October 6, 2021

SUBJECT: Groundwater Extraction and Treatment System - Materials Management Plan  
Approval to Manage Contaminated Soil under Wis. Adm. Code § NR 718.12 and  
Response to Other Management for Contaminated Soil and Groundwater  
JCI/Tyco FTC PFAS, 2700 Industrial Parkway South, Marinette, WI  
DNR BRRTS Activity #: 02-38-580694

**Summary of JCI/Tyco’s Material Management Plan**

**DNR Review**

**GROUNDWATER EXTRACTION AND TREATMENT SYSTEM (GETS) INTERIM REMEDIAL ACTION SITE PLAN**

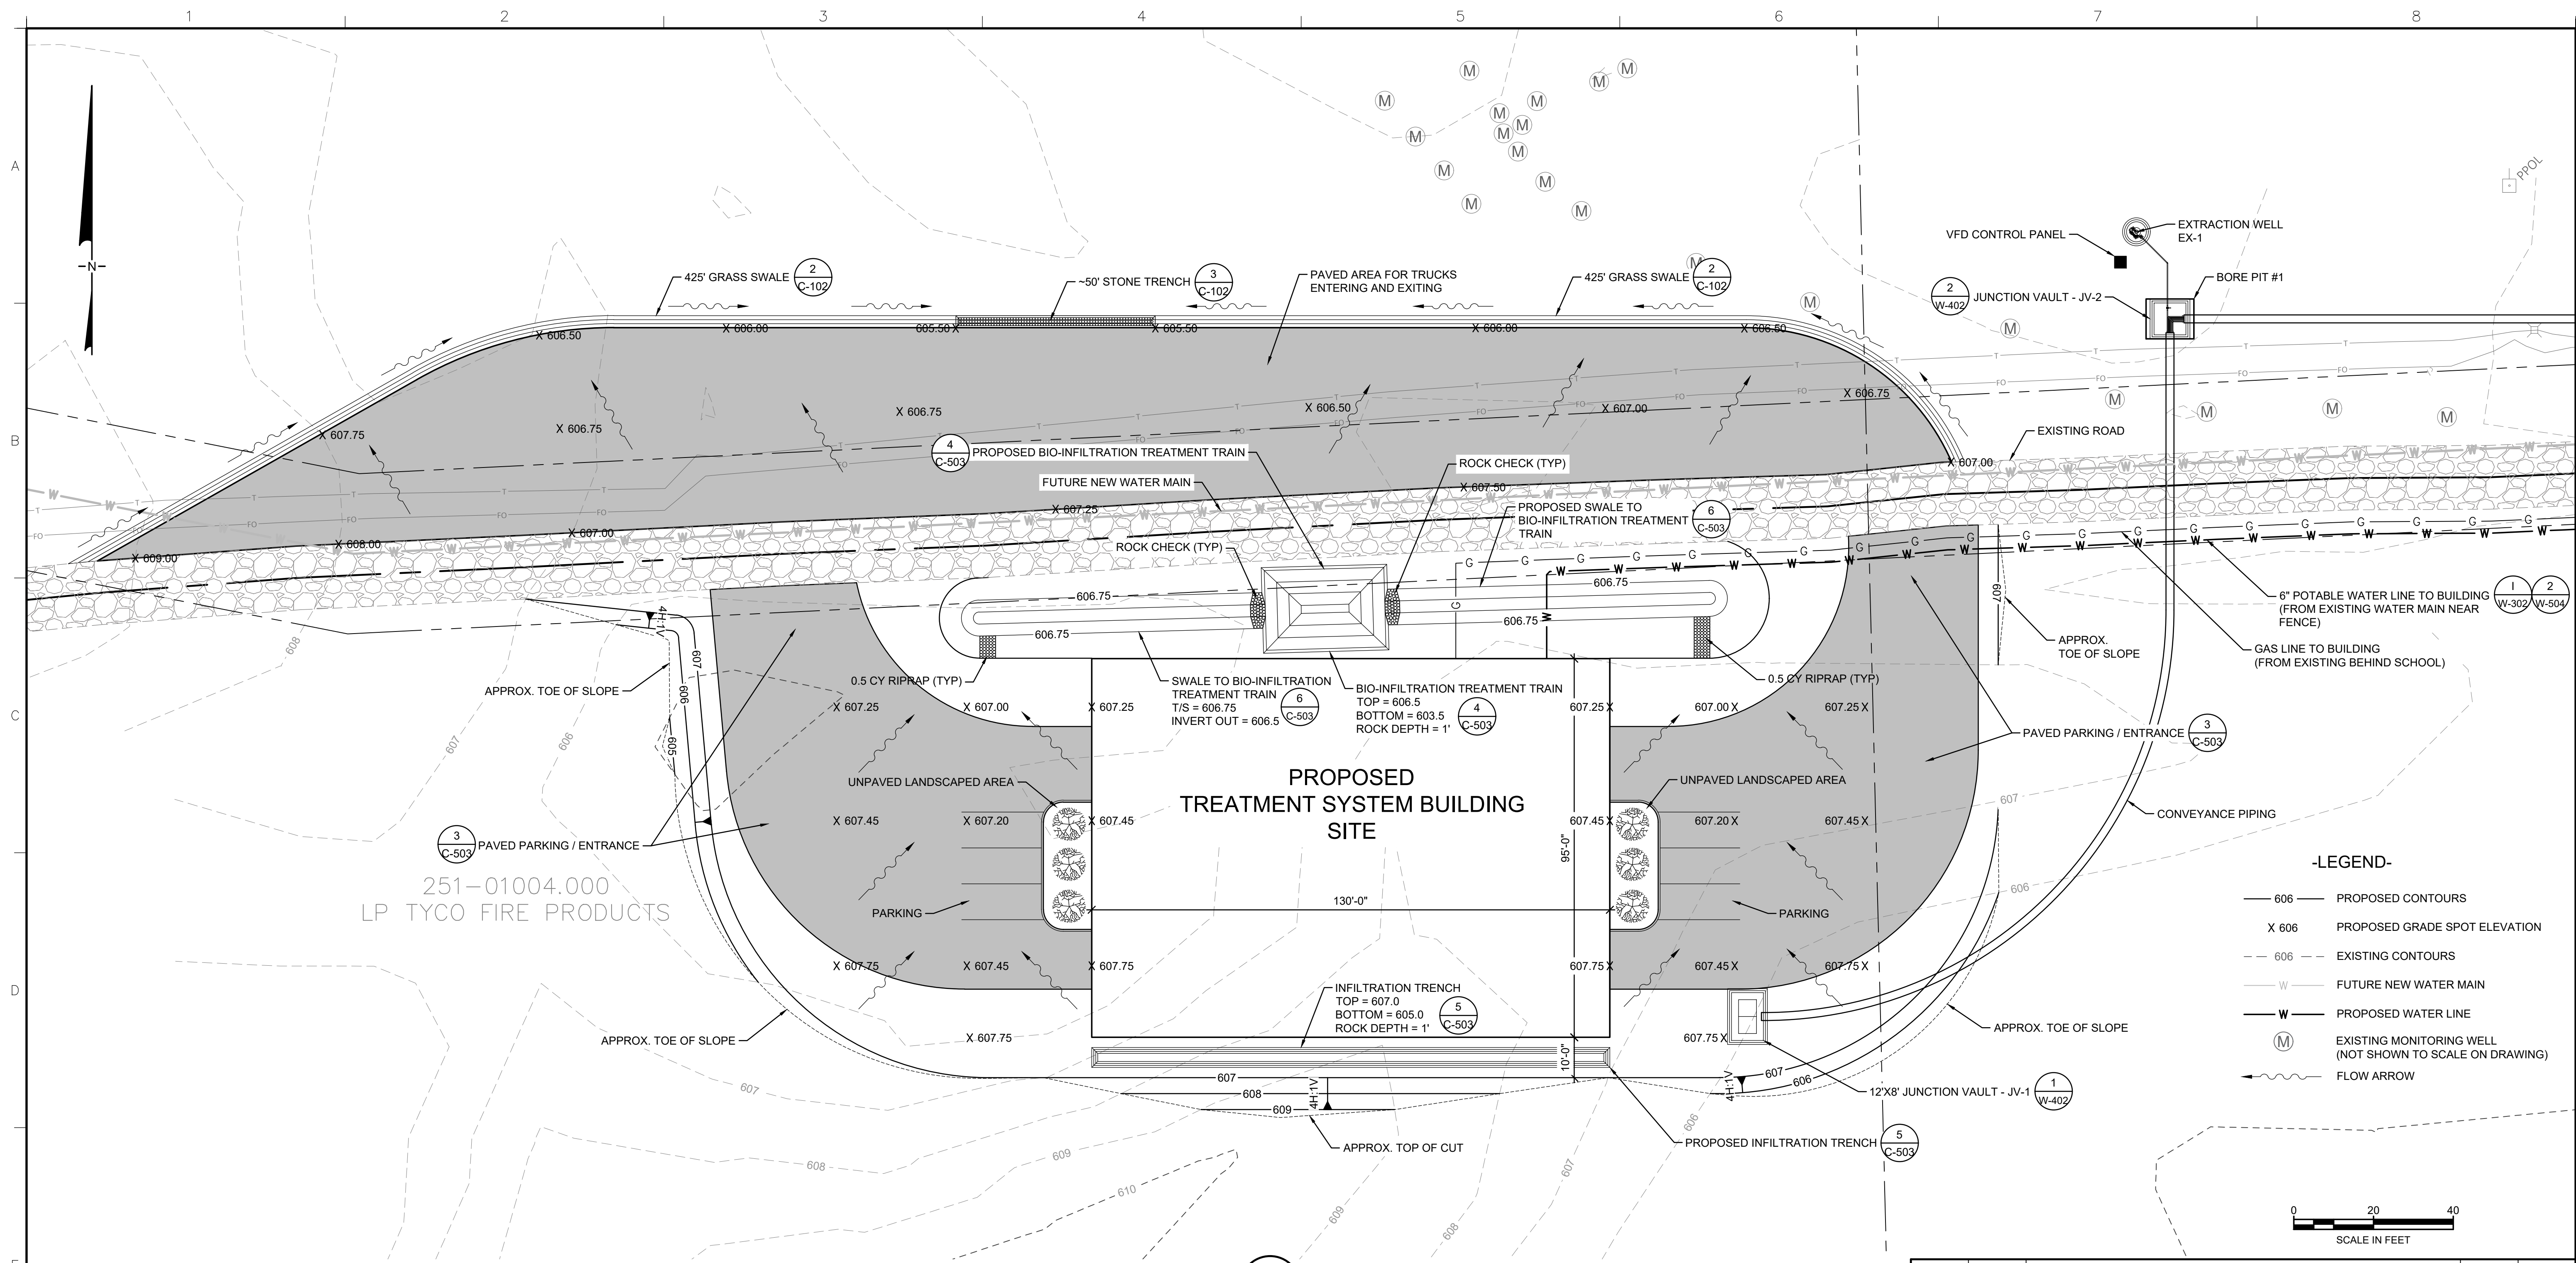
Geosyntec stated in the GETS MMP that the grading area around the GETS treatment building where excess soil will be managed meets the locational criteria listed under Wis. Adm. Code § NR 718.12(1)(c). Two figures with the location of GETS treatment building and grading area are provided in **Attachment B**. These figures are from previous submittals for the GETS; Figure 3-1 is from the February 26, 2021 Interim Remedial Action Design Report and Drawing C-102 is from the August 18, 2021 Stormwater Management Report.
